**Addendum No: Four (4)**

**Project: College Oaks Elementary – Hurricane Laura Repairs**

**Architect's Project No: HL-010-01**

**Date: January 21, 2021**

**4 REGLET MOUNTED COUNTERFLASHING**  
SCALE: 3" = 1'-0"

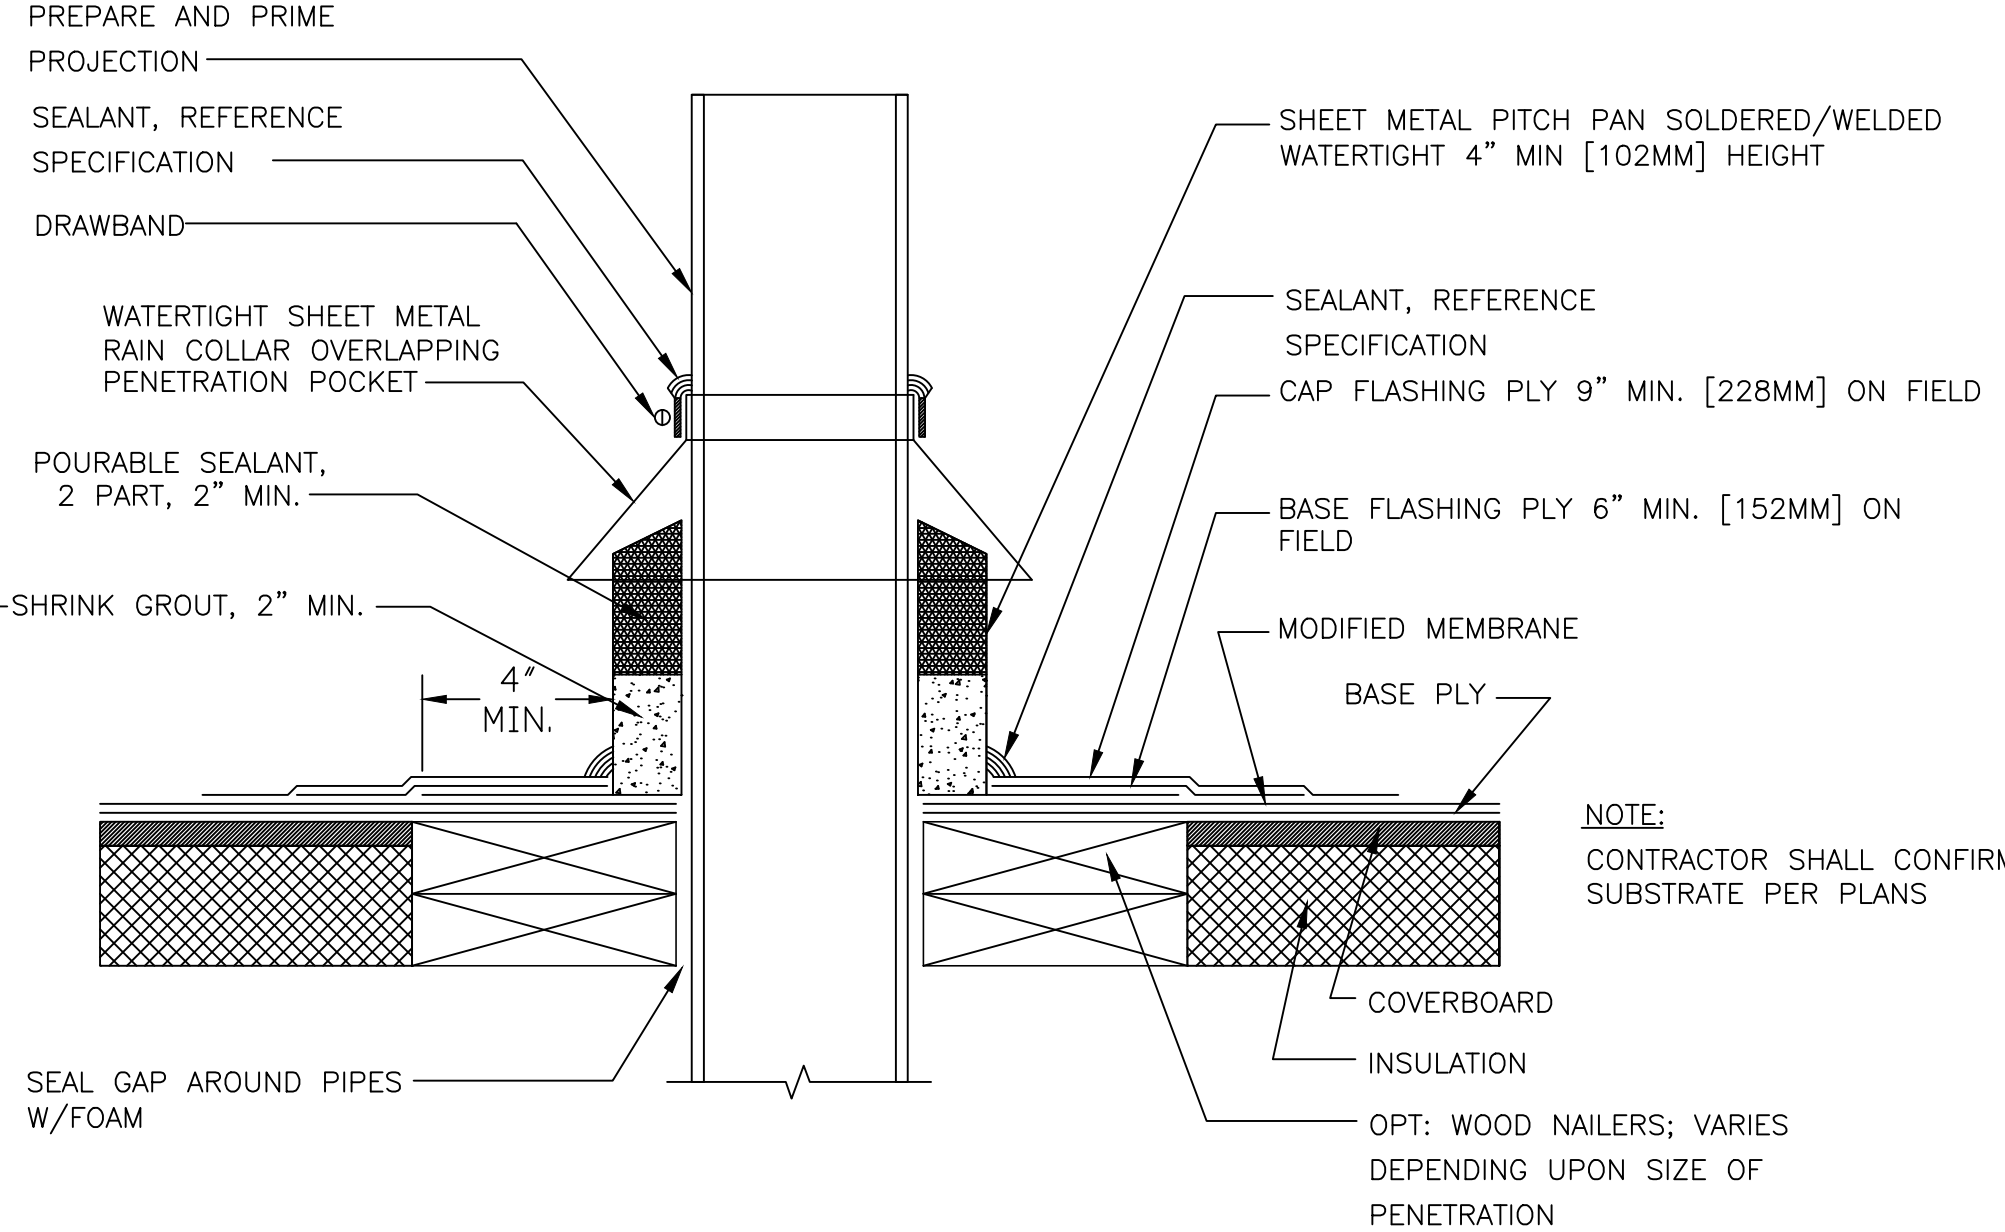
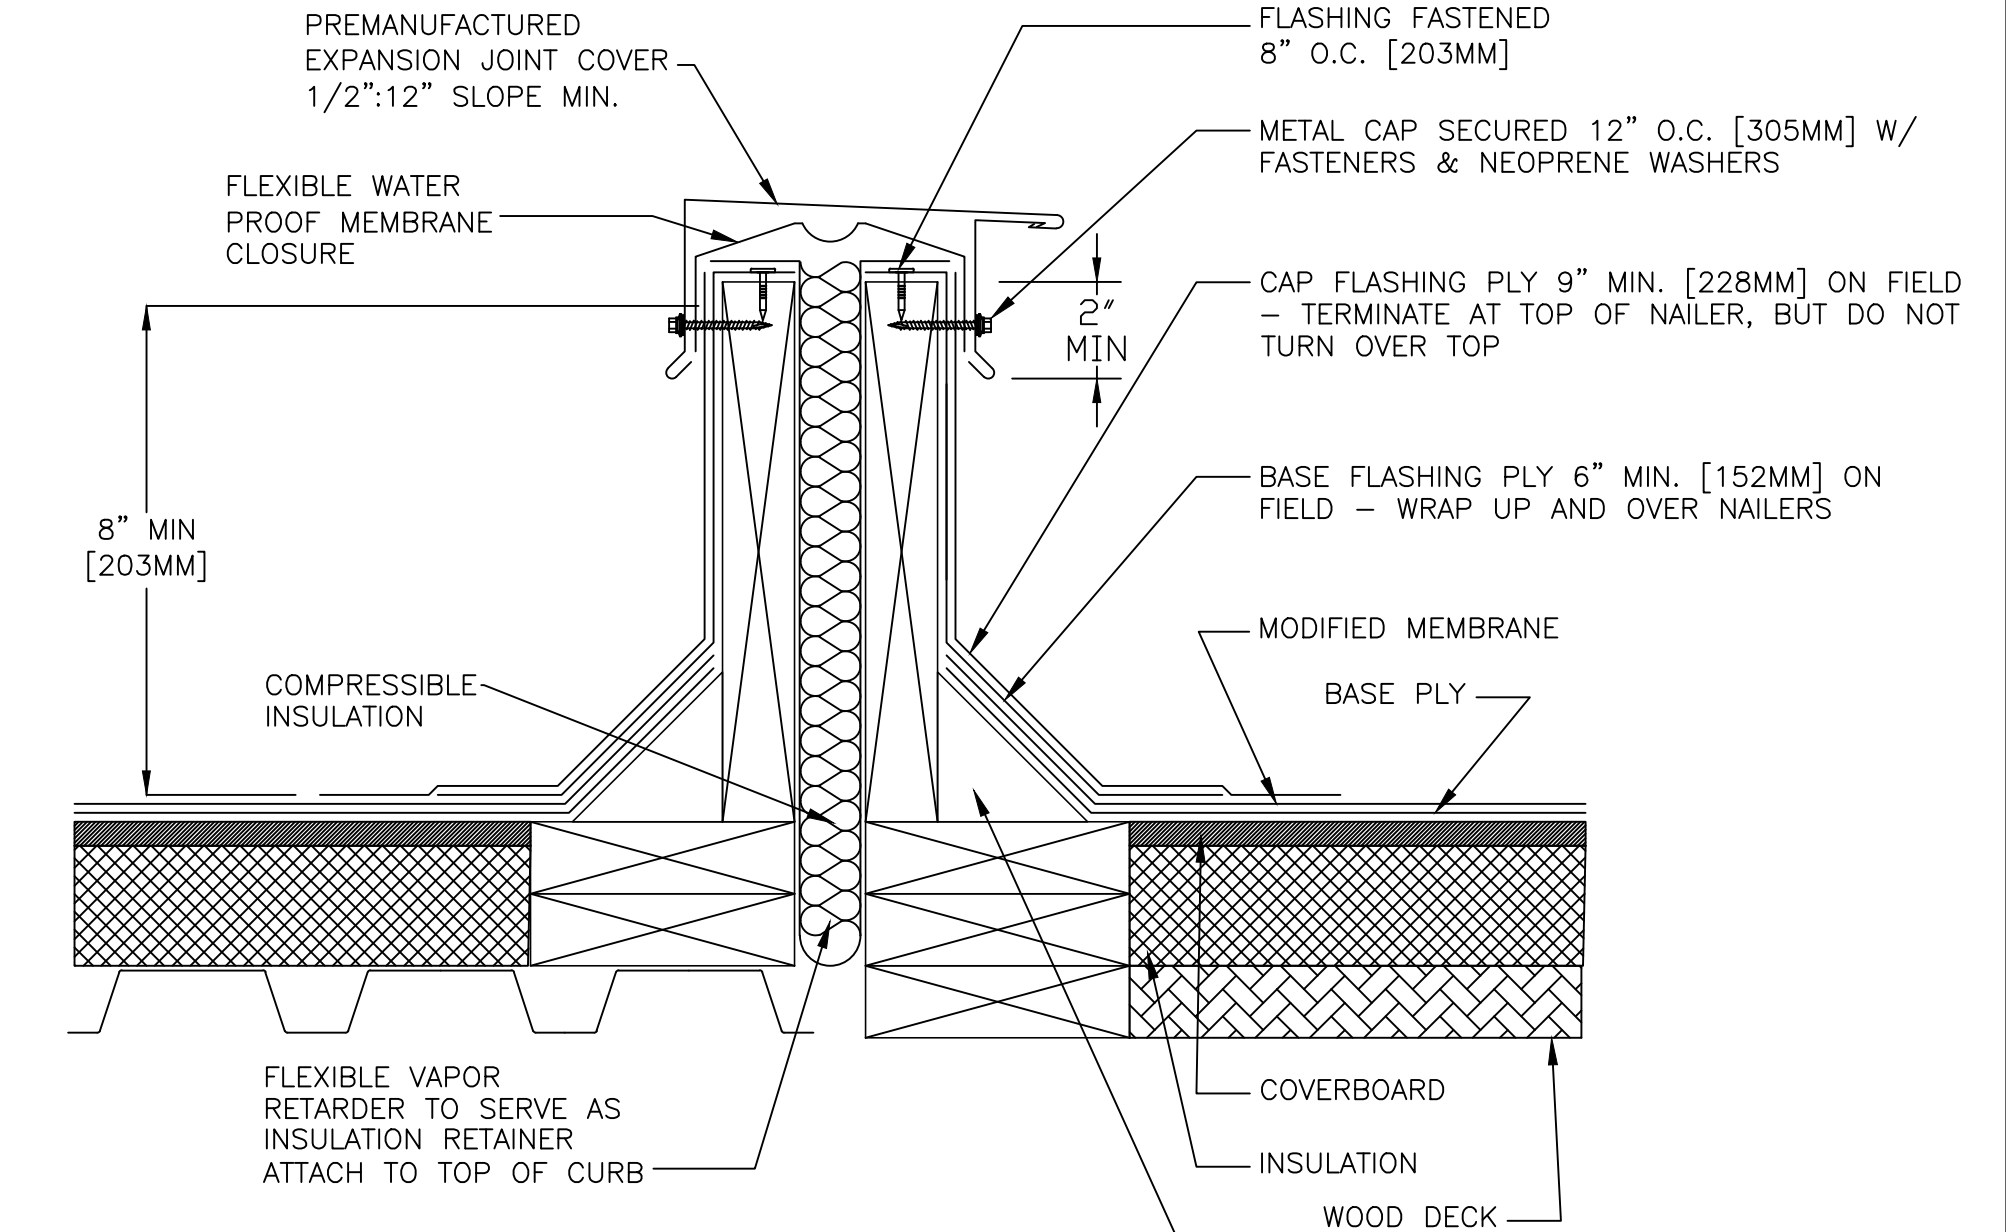
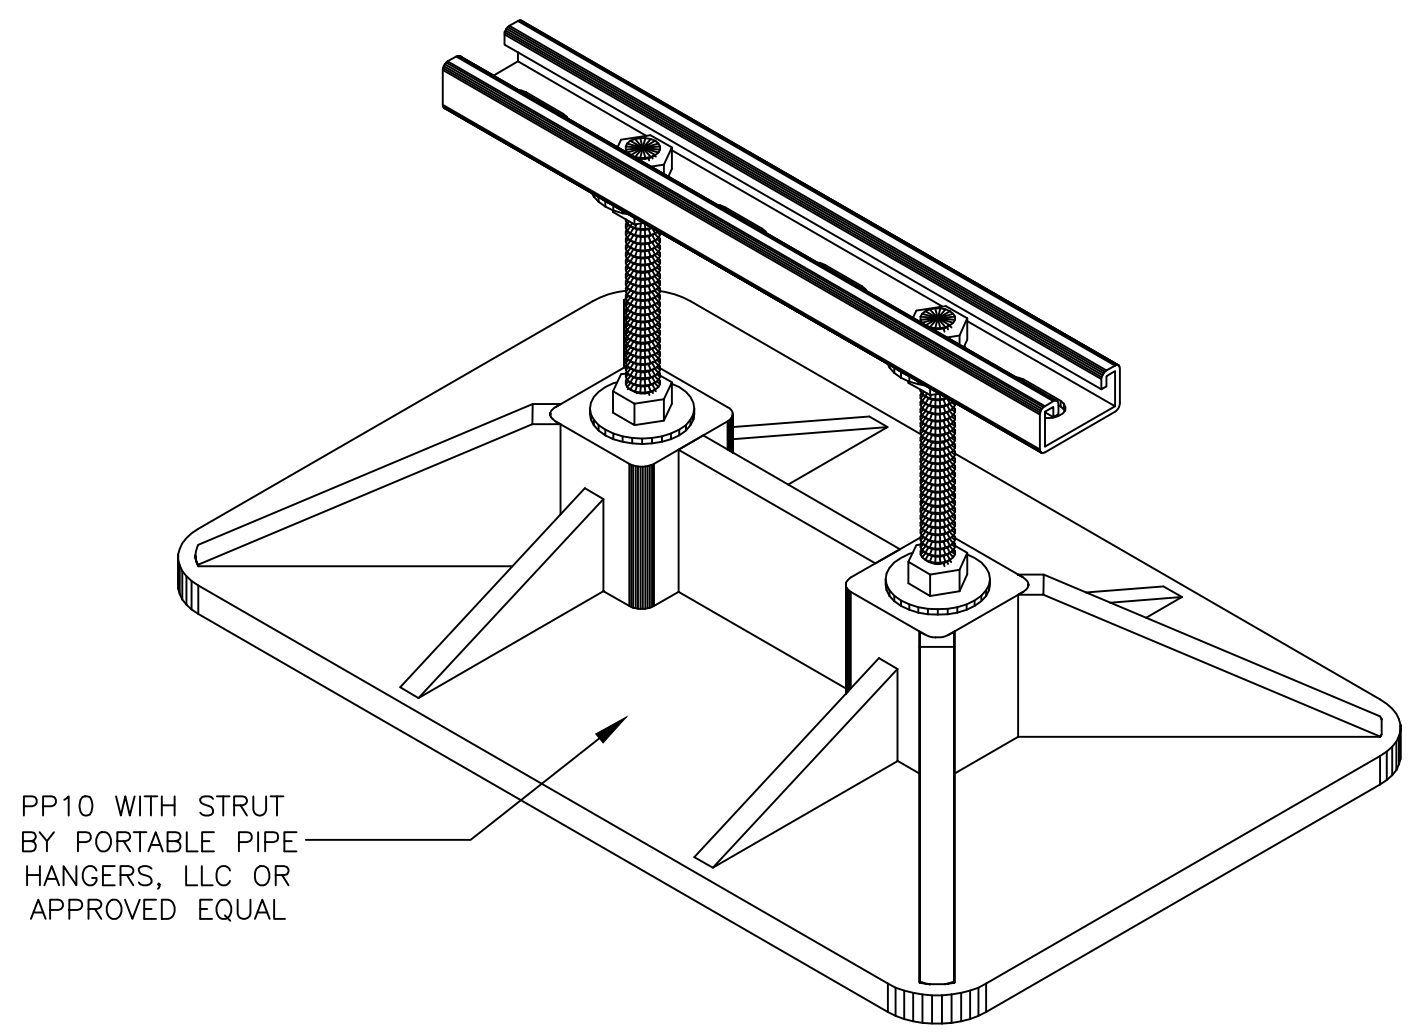
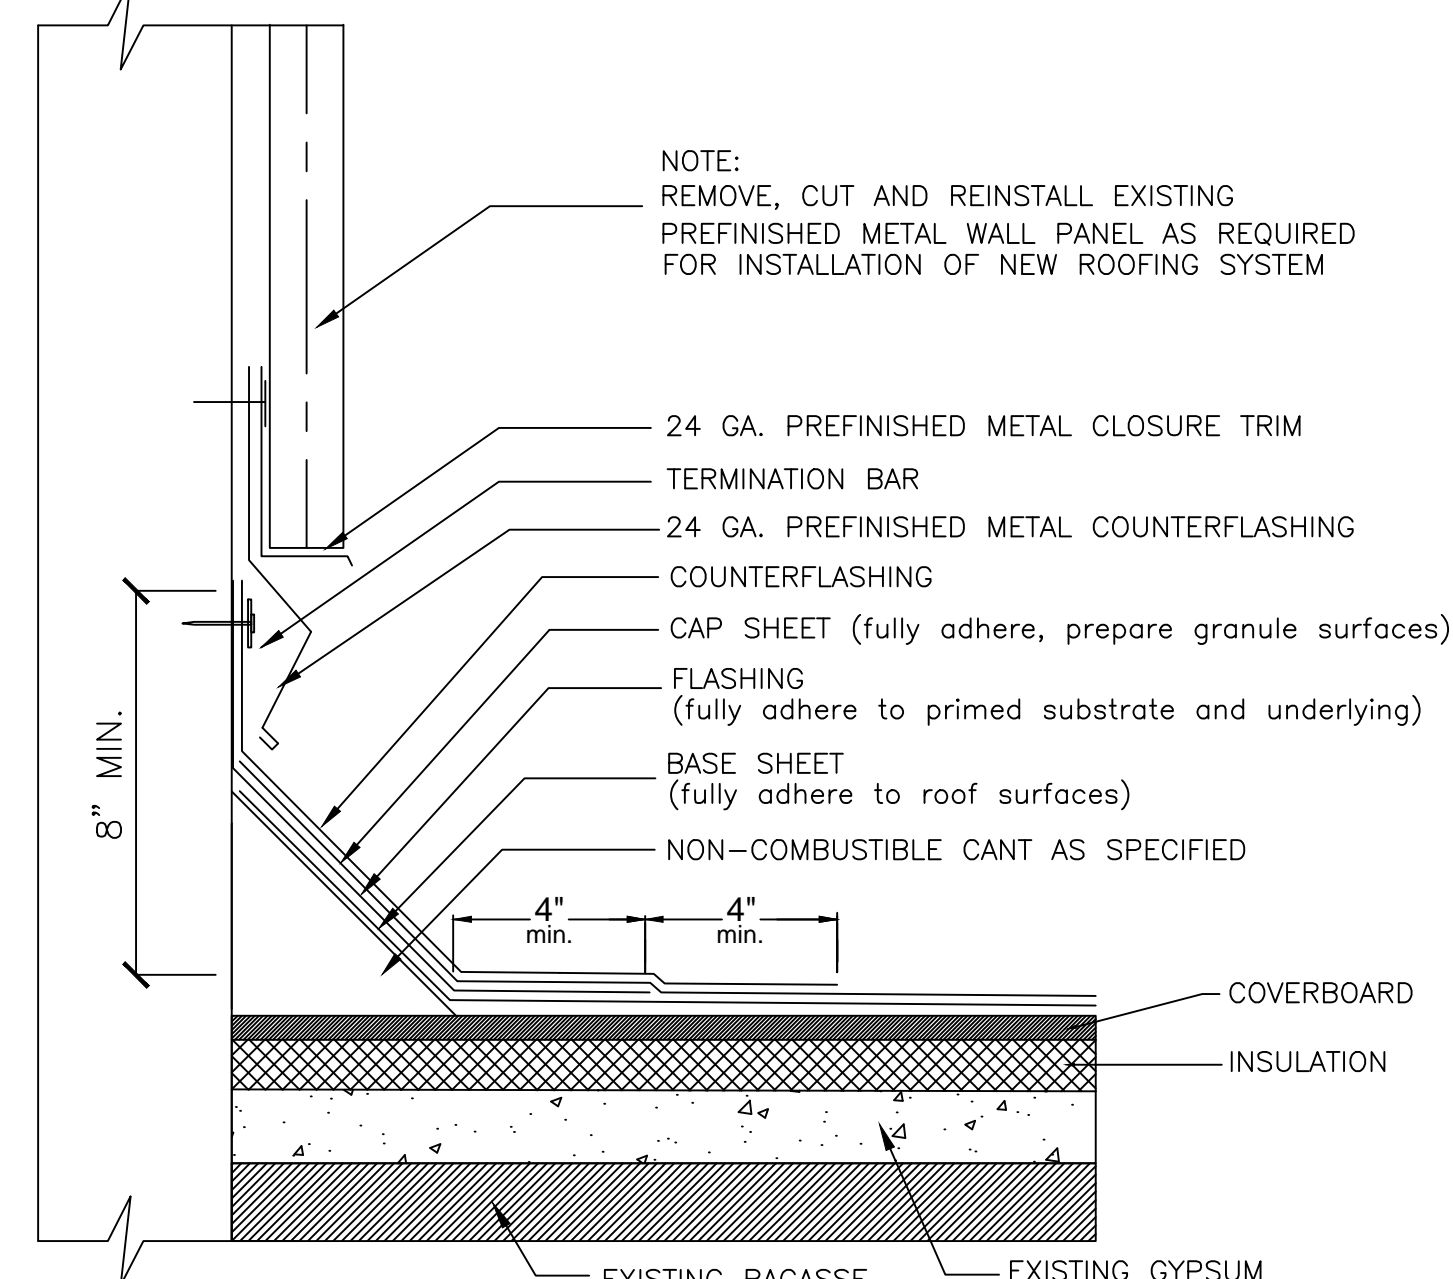
- 7) Sheet A3.1 – Remove existing and replace with revised (See Attached)
- 8) Sheet A3.2 – Remove existing and replace with revised (See Attached)
- 9) Sheets A1.1 & A2.1 – Regarding two (2) temporary buildings to the south of classroom 167 – Contractor shall remove and replace the existing ceiling grid and ceiling tile with new in both (32' x 32') buildings. New ceiling tile shall be Armstrong 1728A 2x2 or approved equal. Contractor shall remove (3' x 3') broken glass window and replace with new. Seal to existing window frame.
- 10) Sheet MP1.1 – Remove and replace with revised (See Attached)
